Reverse Gate Adjustment - Sport Jet 175 XR²

Models Affected

All Sport Jet 175 XR² Models

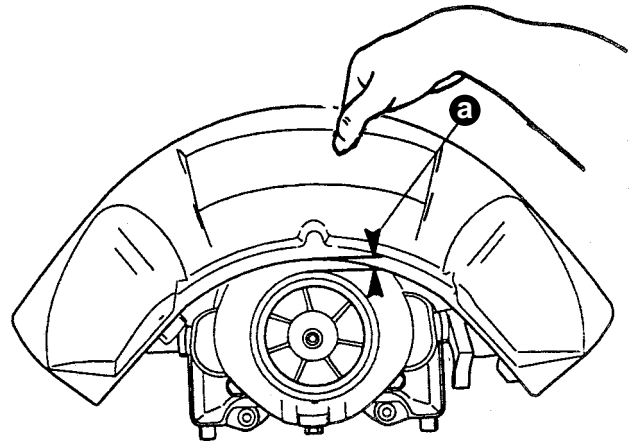
We have received reports from the field of failed reverse gate stops. Review of these failures indicate the cause was due to improper adjustment of the shift cable. If the lower edge of the reverse gate is not 3/8" (9.5 mm) to 1/2" (12.7 mm) above the edge of the steering rudder after removing the shift cable slack in the forward position, damage to the stops and reverse gate may occur.

To check shift cable adjustment, first shift the remote control lever into the forward position. Apply a light downward pressure on the reverse gate until all slack is removed from the shift cable. While maintaining the downward pressure to remove the cable slack, measure the distance between the lower edge of the reverse gate and the upper-most portion of the steering rudder (dimension "a" in figure below). This dimension should be between 3/8" (9.5 mm) to 1/2" (12.7 mm). If the clearance is less than 3/8" (9.5 mm), readjust the shift cable as outlined in the installation manual (P/N 90-10164970) or the service manual (P/N 90-852396).

a - 3/8" (9.5 mm) to 1/2" (12.7 mm)

If the clearance is within the specification, check the reverse gate forward stop adjustment.

If the cable slack is not sufficient to allow the reverse gate to move, adjust the forward stop to allow the specified movement. Refer to the installation or service manual for complete instructions.
